Subject: WRD Comments on Proposed Plan for OU-2 Groundwater Contamination
Omega Chemical Superfund Site, Whittier, California

**Technical Memorandum
Omega Chemical Superfund Site
WorleyParsons
October 7, 2010**

**RE: TECHNICAL MEMORANDUM
 OMEGA CHEMICAL SUPERFUND SITE, WHITTIER, CALIFORNIA**

Figure 1. Scatter Plot of Simulated and Observed Water Levels, Excerpted from RI Report Figure K-10.

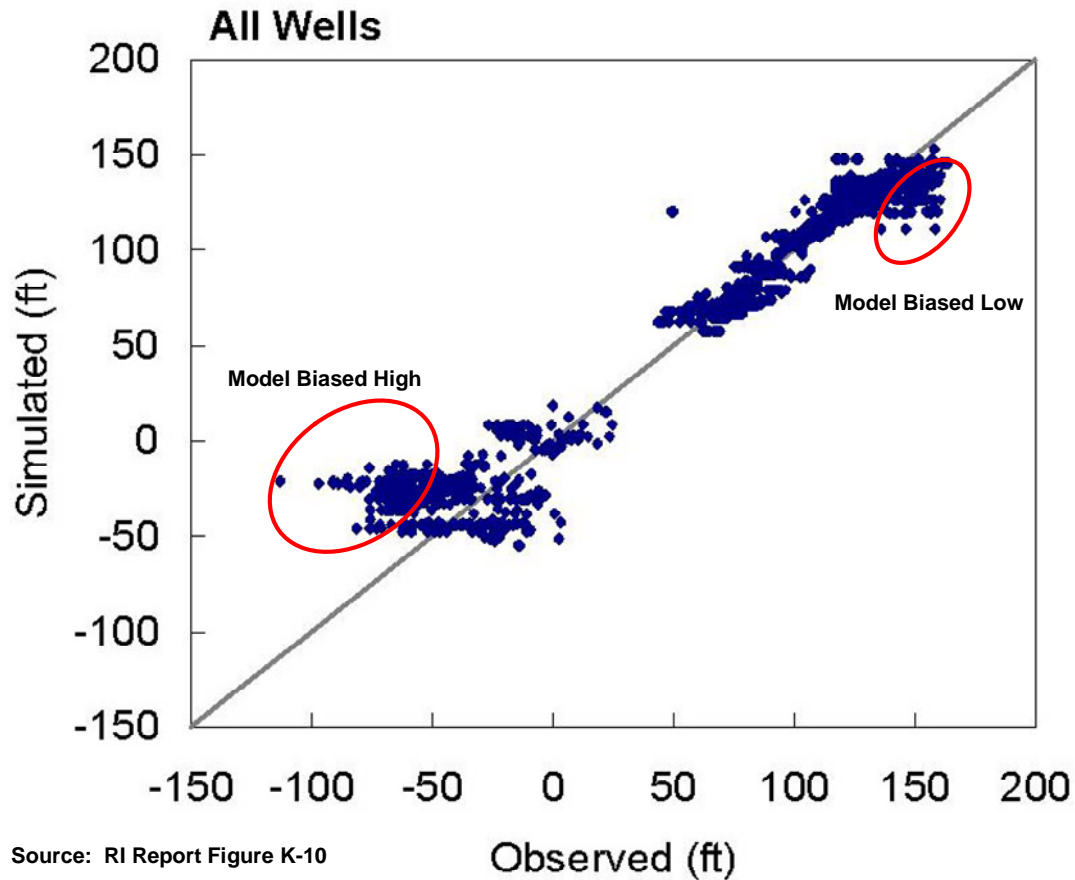
An important weakness of the RI model is its inability to accurately represent the vertical head differences, and therefore the vertical hydraulic gradient, between the upper stratigraphic units and deeper units in which contamination is observed, particularly stratigraphic units 4 to 6. As noted in the response to Question 1, the difference in groundwater elevation between shallow and deep stratigraphic units is commonly 10 to 20 feet, and these head differences represent significant downward vertical hydraulic gradients. However, there is bias in the RI Model such that simulated groundwater elevations in shallower units with higher groundwater elevations are biased low, while at the same time simulated groundwater elevations in deeper units with lower groundwater elevations are biased high, such that the net effect is a simulation that under-represents the vertical head difference and therefore, the downward vertical gradients (i.e., downward contaminant migration). This bias can be observed in the scatter plot of observed versus simulated heads in Figure K-11 of the RI Report, a portion of which is represented in Figure 1, below:

As noted in the circled areas in Figure 1, above, the magnitude of the bias in the model is commonly 20 feet or more in the highest and lowest heads in the model, effectively negating any downward vertical gradient.

Figure 2. Simulated and Observed Hydrographs, Excerpted from RI Report Figure K-12.

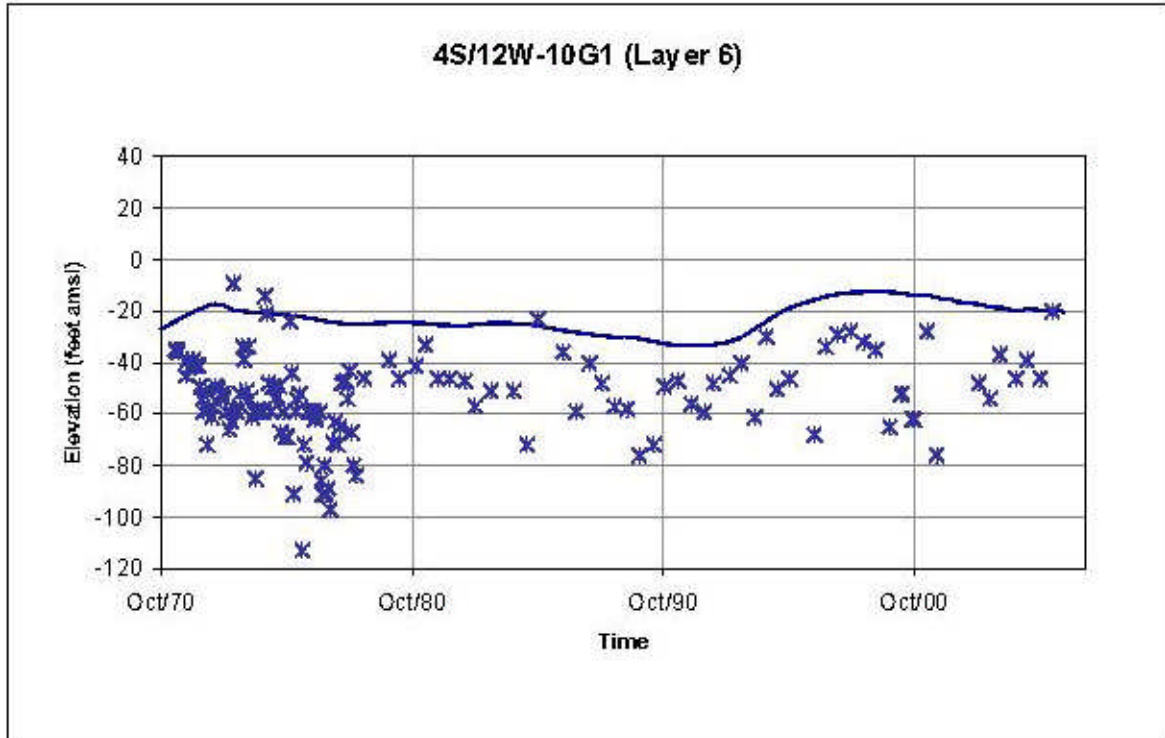
Another example of the bias in the modeled heads is shown in the transient calibration against observed hydrographs, an example of which is shown in Figure 2 below, from Figure K-12 of the RI Report:

The above plot shows that simulated groundwater elevations for a deeper model layer (layer 6; stratigraphic unit 4) are consistently high compared to observed values. Again, the effect of this bias is to underestimate the vertical hydraulic gradient.

Figure 3. Scatter Plot of Simulated and Observed Water Levels, Excerpted from FS Report Figure A-10

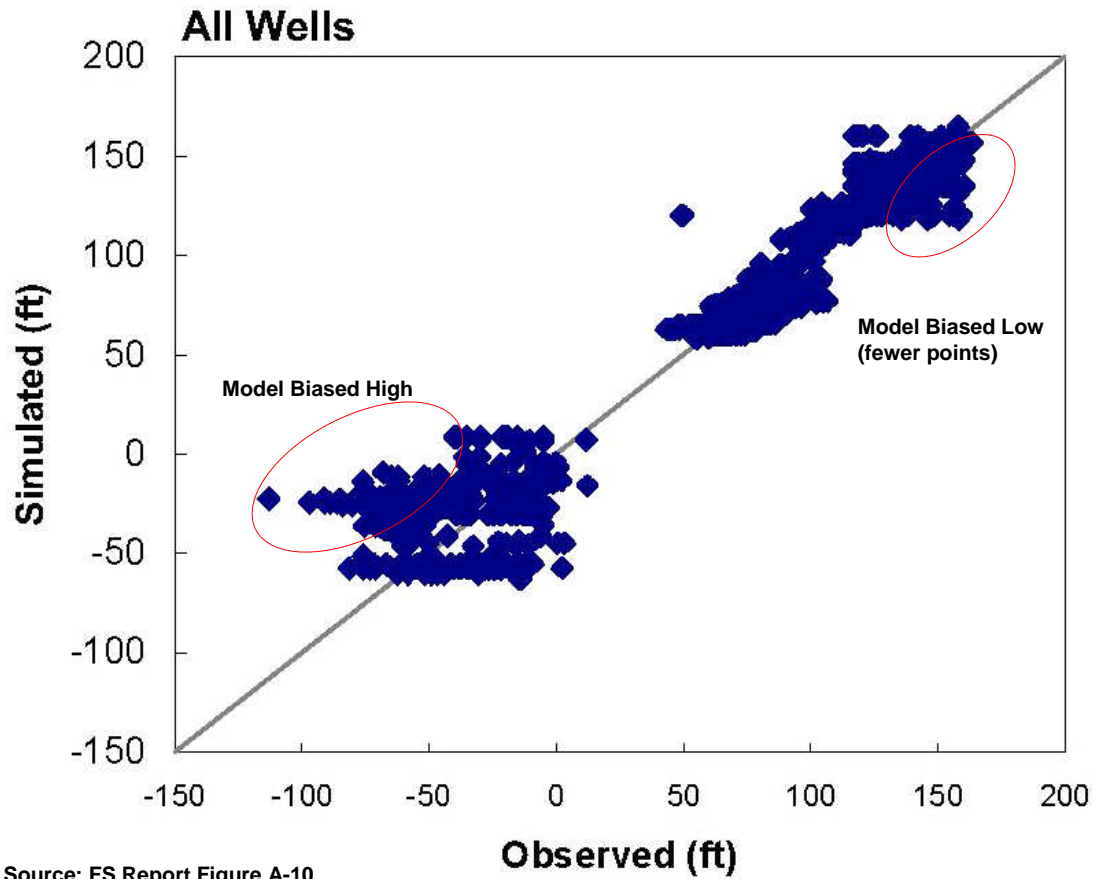
The refined groundwater model of the FS Report shows less bias in the simulated groundwater elevations, although there is still appreciable bias of the same kind shown in the RI model. The scatter plot from Figure A-10 of the FS Report is shown in Figure 3, below:

Figure 4. Simulated and Observed Hydrographs, Excerpted from FS Report Figure A-11.

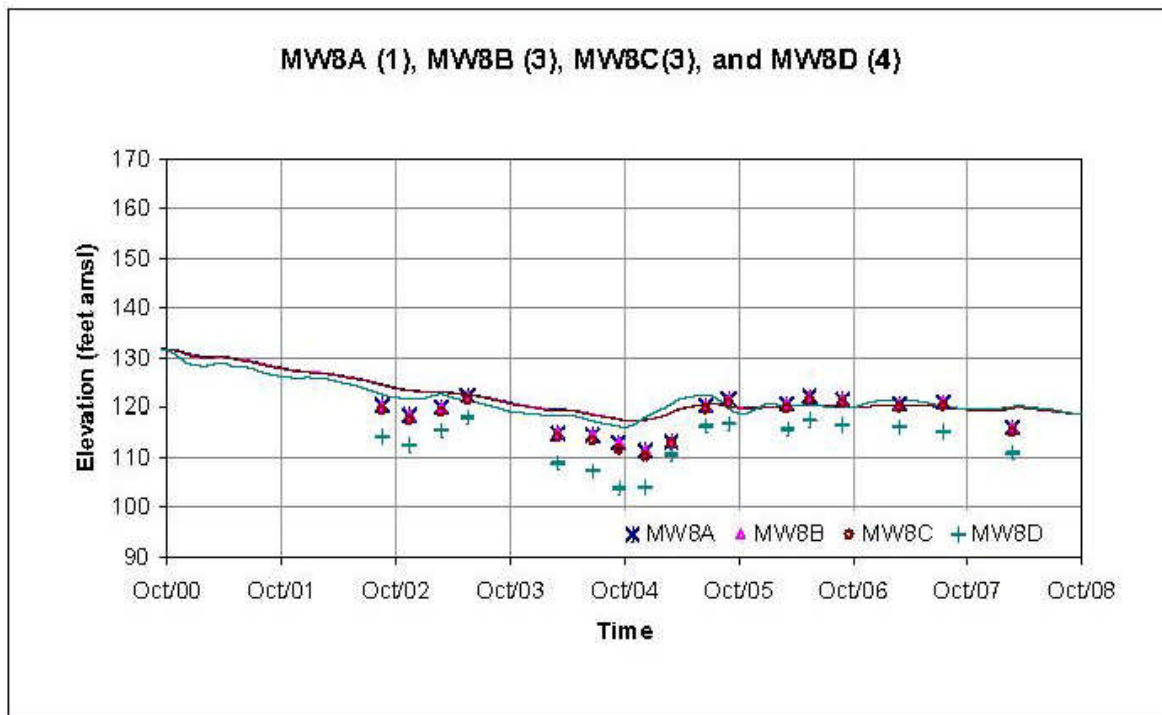
Similarly, the transient model hydrograph in the FS model still shows that while groundwater elevations in shallow units are generally well simulated, groundwater elevations in deep units are still simulated high, again under-representing the vertical hydraulic gradient. For example, the following transient calibration hydrograph (Figure 4) is from FS Report Figure A-11:

Figure 5. Time-Series Plot of TCE in the Pioneer 1 Well, Showing Breakthrough Curve for TCE.

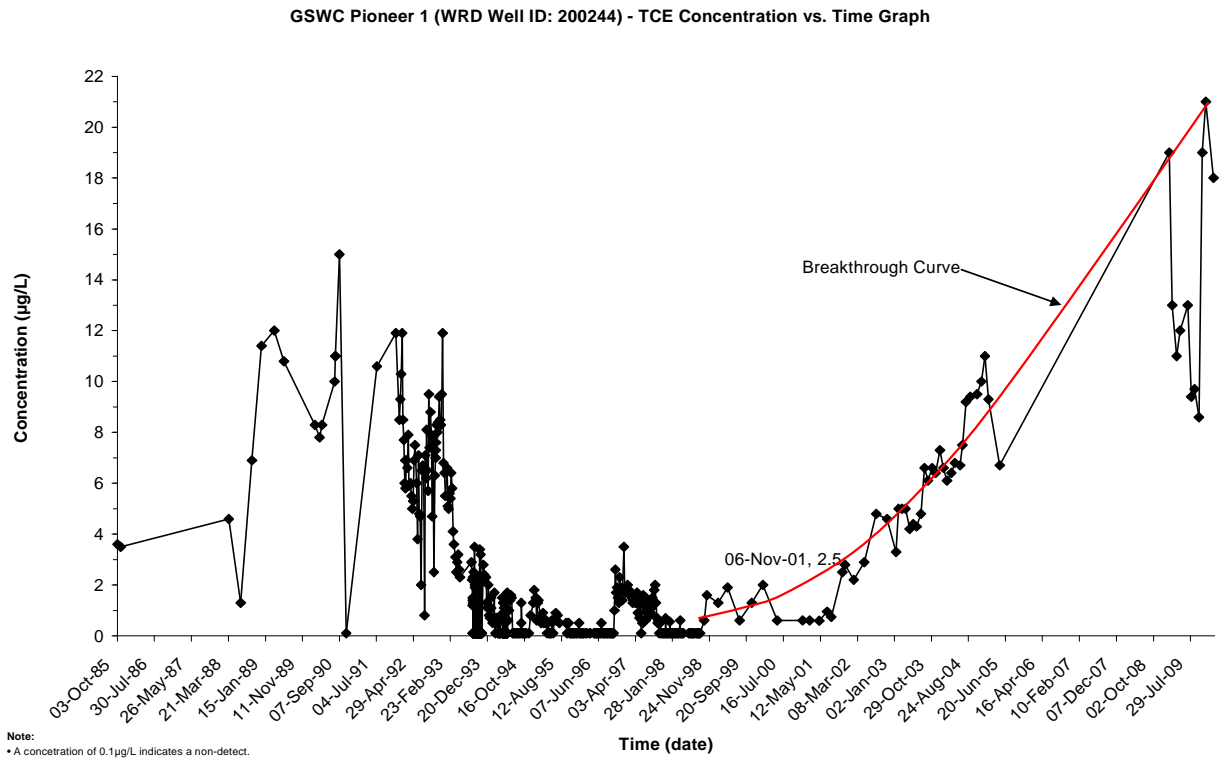
Another line of evidence that contamination in at least the Pioneer wells is from the Omega plume is the observed breakthrough of PCE and TCE at these wells. The breakthrough of TCE in the Pioneer 1 well is shown in the following time series plot (Figure 5):

The breakthrough of TCE in the well begins somewhere between late 1998 and late 2001, but is clearly in progress by November 2001. Pre-mid 1990's TCE appears to reflect a different regional plume that passed through the well from the mid 1980s until about 1996.

**Figure 6. Time-Series Plot of TCE in the Pioneer 1 Well, Showing Breakthrough Curve for PCE.**

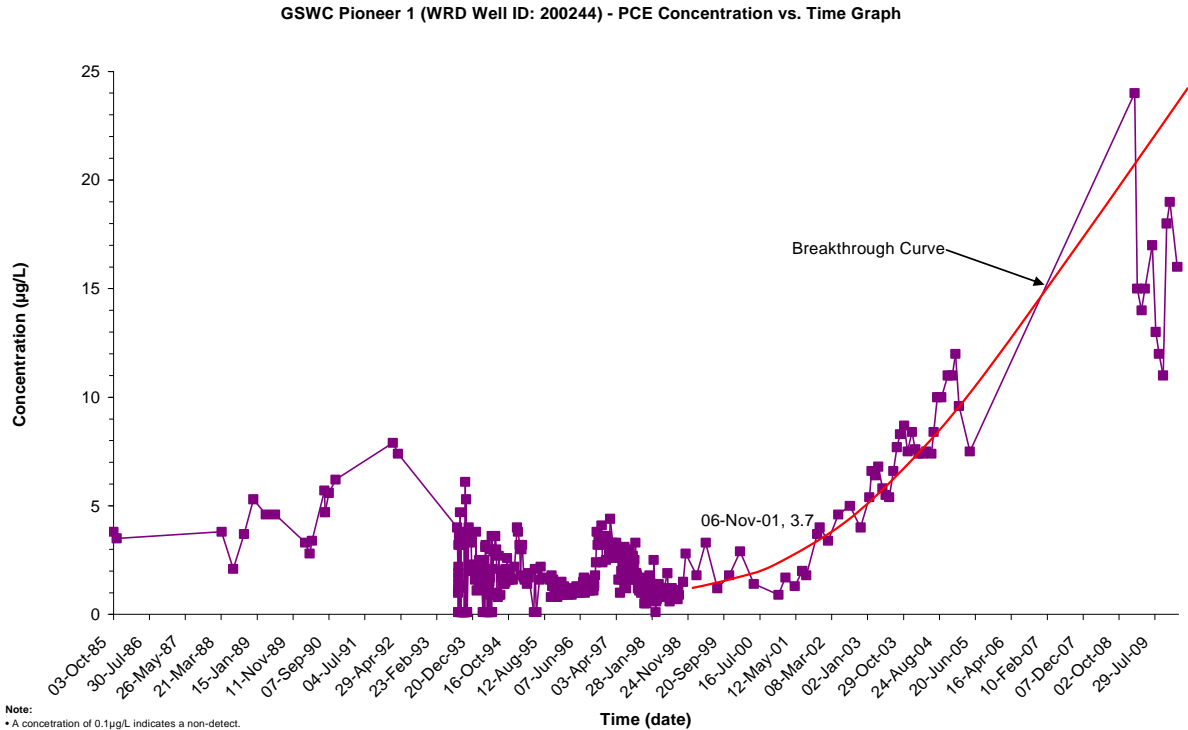
A similar pattern of breakthrough is observed for PCE in the Pioneer 1 well, as shown below (Figure 6):

This time series graph shows the same breakthrough curve as for TCE, again beginning between late 1998 and late 2001, but clearly in progress by November 2001. These first arrival times represent a theoretical travel time of 22 to 25 years from the start of operations at the Omega and AMK sites in 1976. These travel times therefore correspond to a groundwater velocity for first arrival of TCE and PCE of 800 ft/year to 909 ft/year. Recognizing that first arrival time is appreciably faster than the advective velocity (as noted in the RI Report) and the several times factor of uncertainty in the USEPA's 620 ft/yr average advective velocity, the above travel times are well within reason for a source at the Omega/AMK sites (note that travel time from the AMK Sites would be 11 years less than that from the Omega Site (RI Report p 6-18) at an advective velocity of 620 ft/year).

Figure 7. Capture Zone Map, Pumping Scenario with Plume-wide Extraction, Excerpted from FS Report Figure A-14.

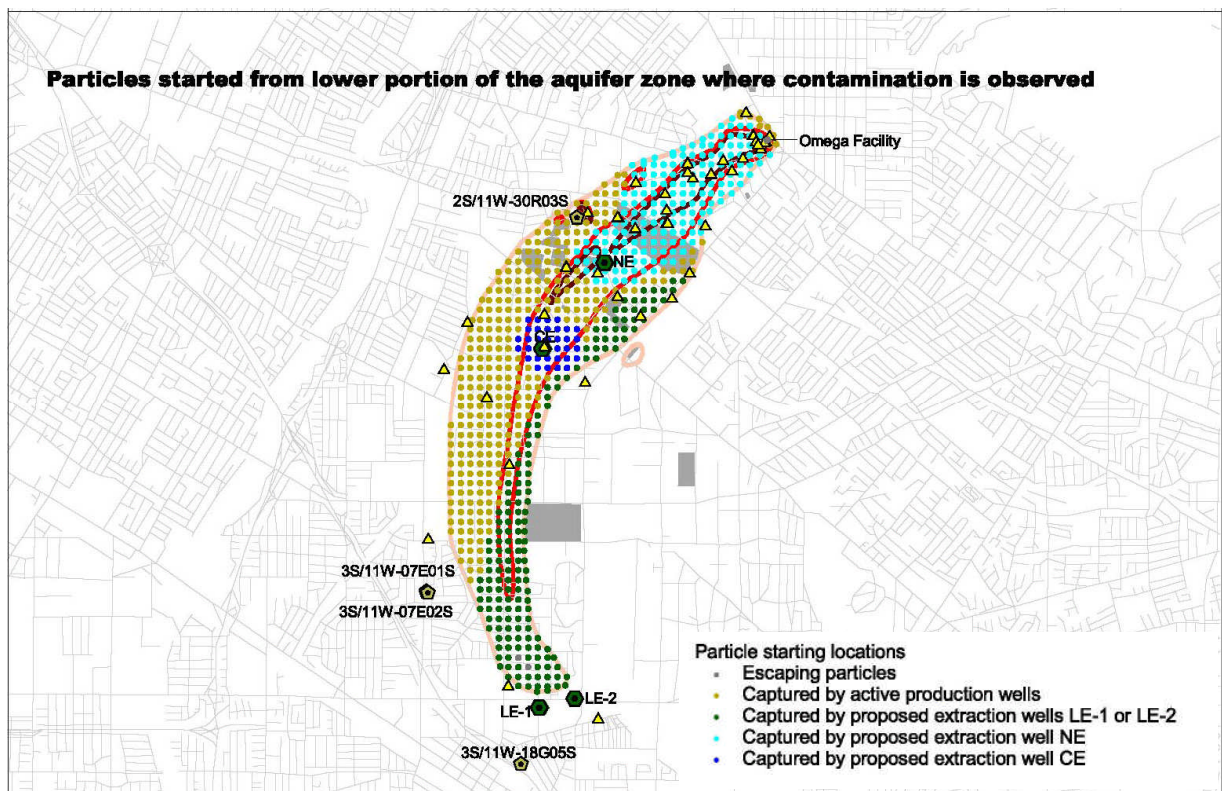
An example of the capture zone modeling results is shown in Figure 7 for the lower aquifer zone under plume-wide extraction (complete FS Figures A-13 and A-14 are included in Appendix B). All of the yellow-colored particles are captured mainly by the GSWC production wells.

The capture zone modeling indicates that very few particles escape capture by either the extraction wells or production wells, suggesting that either the leading edge or plume wide extraction alternative (including GSWC production wells) should be able to capture the entire OU2 plume.

Figure 8. Simulated PCE Plume After 5 Years of Pumping, Lower Aquifer Zone, Plume-wide Extraction Scenario, Excerpted from FS Report Figure A-17-3.

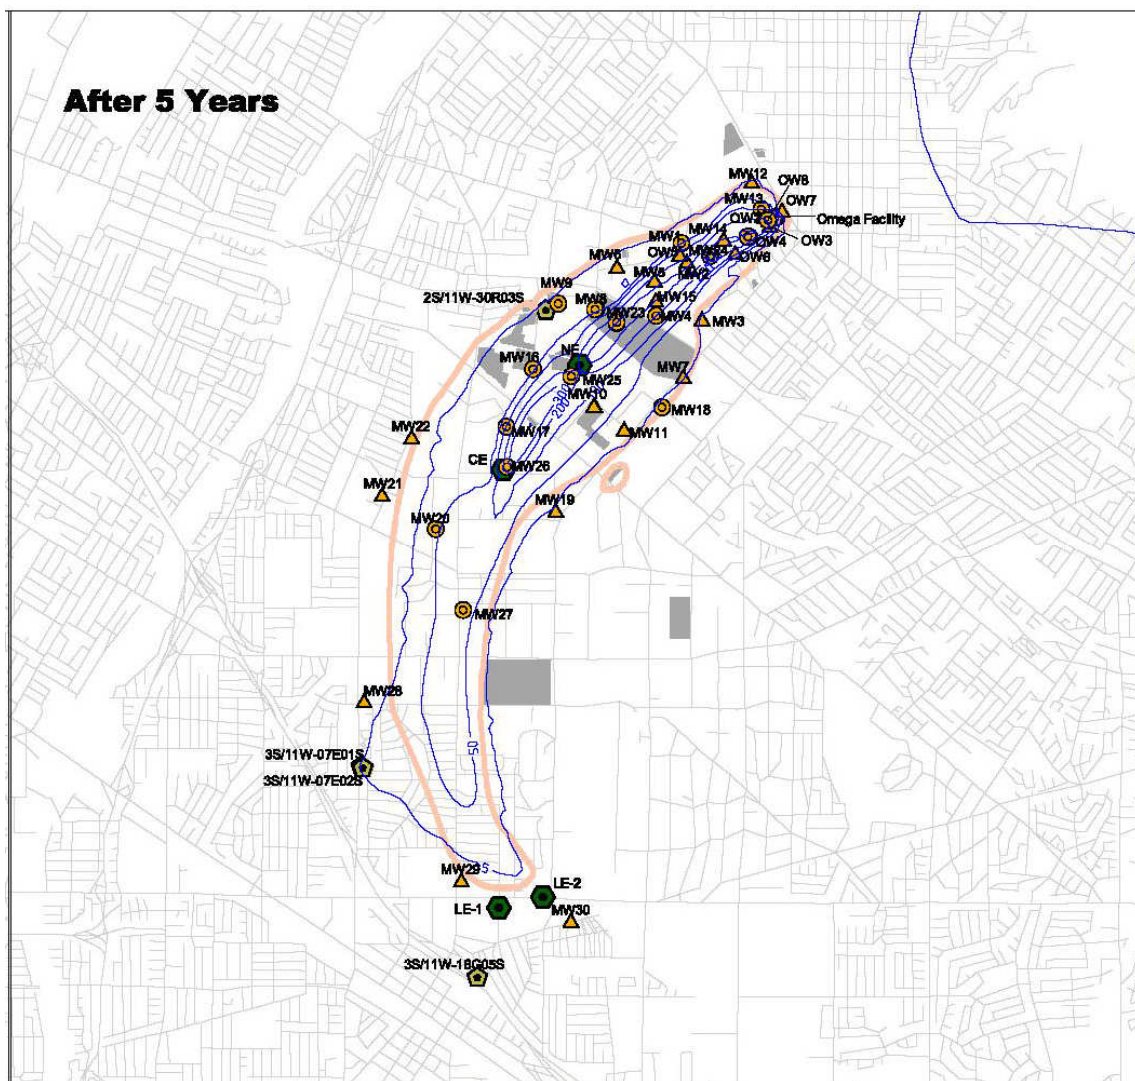
The capture zone simulations are supported by the solute transport modeling of remedial extraction alternatives (FS Report, Appendix A). The transport modeling shows that for all three remedial alternatives (i.e., no action, leading edge extraction, and plume-wide extraction), the plume in the “Lower Aquifer Zone” (again, terms are not defined in the FS Report) is intercepted by GSWC Pioneer 1 and 2 wells within five years after the start of extraction. In the “Middle Aquifer Zone,” the plume is intercepted by Pioneer 1 and 2 wells between 10 and 20 years after the start of extraction. Figures A17-2 and A-17-3 of the FS Report show the transport modeling results for the preferred plume-wide extraction alternative for the Middle and Deep Aquifer zones, respectively. The following Figure 8

shows the modeling results for the Deep Aquifer zone after five years of plume-wide extraction (from Figure A-17-3). Ironically, after five years of remediation extraction under the preferred alternative, the Deep Aquifer Zone plume is being intercepted by the GSWC wells, but not yet by the two leading edge extraction wells. USEPA should consider locating these wells further upgradient, so as to minimize the total volume of clean water pumped before they start to intercept the OU2 plume in excess of MCLs. It would also be appropriate to consider contingency locations (further downgradient) that reflect potential delays in system start-up.

The proposed remedial alternative, including ongoing extraction from the GSWC Pioneer and Dace 1 production wells is likely to prevent further downgradient migration of the OU2 plume in the groundwater interval up to 200 feet depth. However, as noted previously, there may be significant problems with the USEPA conceptual model in terms of plume depth, particularly in the downgradient portion of the plume (for example, where the proposed leading edge extraction wells are located). The proposed depth of extraction wells in downgradient areas is based on the assumption that the plume is limited to 200 feet depth. However there are no data from this depth (or deeper) and no vertical delineation of the plume in the downgradient areas of concern. Consequently, while in the two-dimensional (plan) view, the proposed remedial alternative appears effective in capturing the entire OU2 plume, but there is a very great risk that a deeper portion of the plume (below 200 ft depth) could bypass the remedial extraction wells and pose an ongoing threat to farther downgradient wells, such as the GSWC Imperial wells (which may already be seeing some leading-edge contamination from the OU2 plume). Additional downgradient plume delineation is required, and if needed, the leading edge extraction wells should be deeper.
